## **NTSB Regulatory Interpretation Request Operating Practices Response**

**On April 1, 2021, the NTSB posed the following two similar questions:**

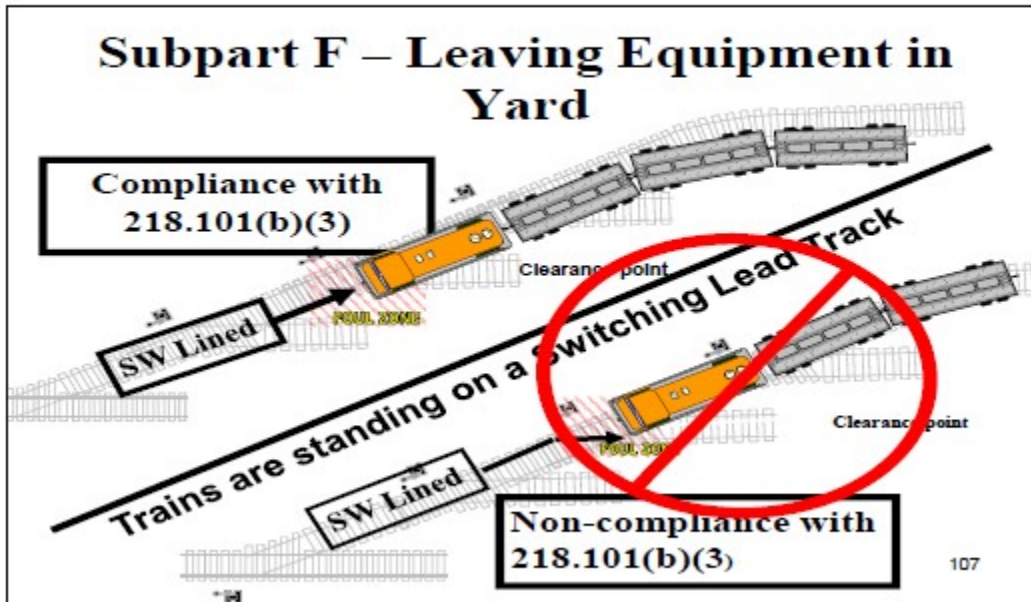
**The following Operating Practices Compliance Manual diagram depicts 218.101(b)(3):**

The above diagram closely reflects the La Mirada accident scenario.

**Therefore, since the track 6802 switch was lined for the lead, there is no fouling violation and is in compliance with the 218.101(b)(3) exception.**
